Project: Plot F, Great Jackson Street

File ref: MEM-1921985-5A-AS-20220303-HSE Gateway One Response

HSE Substantive Response pgo-0684 (Planning Application 132199/FO/2021)

Figure 1 – Building F1

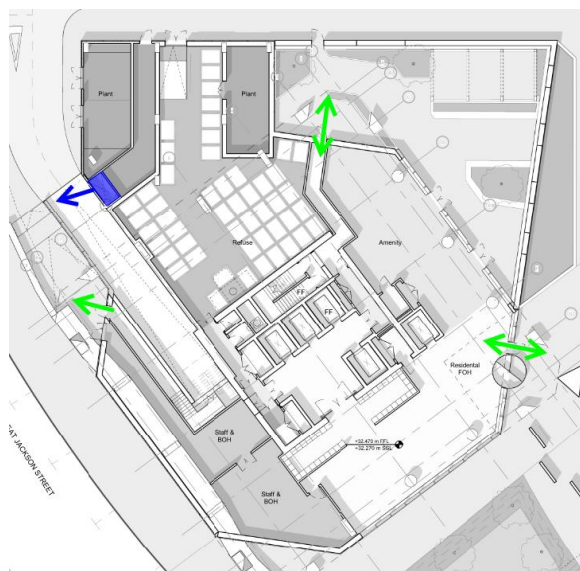
2.1 – Section 7 of the fire statement discusses the provision of a smoke control system in the basement car park levels. However, the information provided does not indicate where smoke would be vented outside. It is important that smoke vented from a basement fire is not able to re-enter the building, affect escape routes or fire service access points. Resolving this issue may affect land use planning considerations such as landscaping and appearance of the building.

Please refer to Figures 1 and 2 below, which highlight the basement smoke extract discharge points (shown in blue). These have been located such that they are not in close proximity to means of escape routes and Fire Service access points (both shown in green).
